DUQUESNE LIGHT COMPANY

Beaver Valley Power Station

INSERVICE TESTING (IST) PROGRAM FOR PUMP AND VALVES

Proposed Revision 2C

RELIEF REQUEST 33

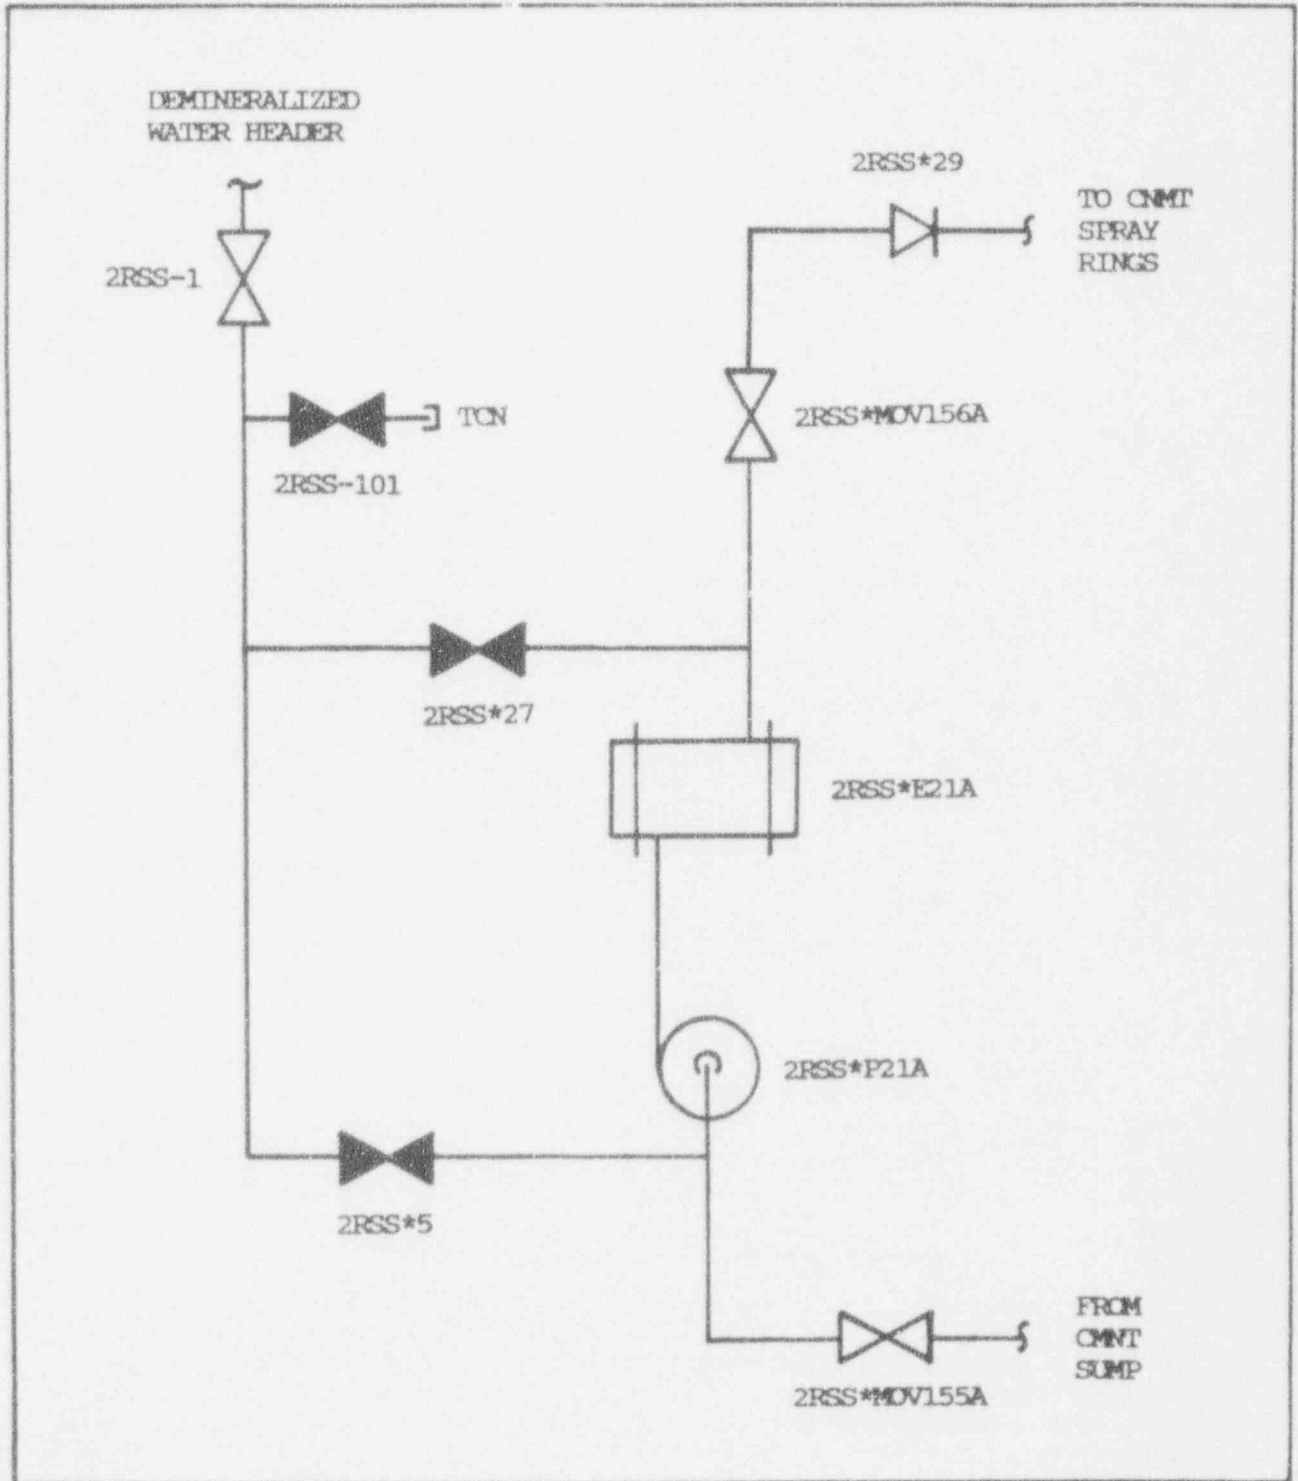
IWV-3426 and 3427(a) require Owner specified maximum permissible leakage rates for specific valves as a function of valve size and type, and provide the corrective action to be followed when these limits are exceeded.

These valves provide isolation between the demineralized water header and the "A" Recirculation Spray Pump suction and discharge piping as shown on the attached figure. The configuration of these valves (i.e., two in parallel) is such that individual leakage rates for each specific valve cannot be determined using the test method of IWV-3424. In this case, assigning maximum permissible leakage rates for each valve would not be practical.

Assign a maximum permissible leakage rate for both 4 inch valves as a unit to then be used as the criteria for initiating corrective actions in accordance with IWV-3427(a).
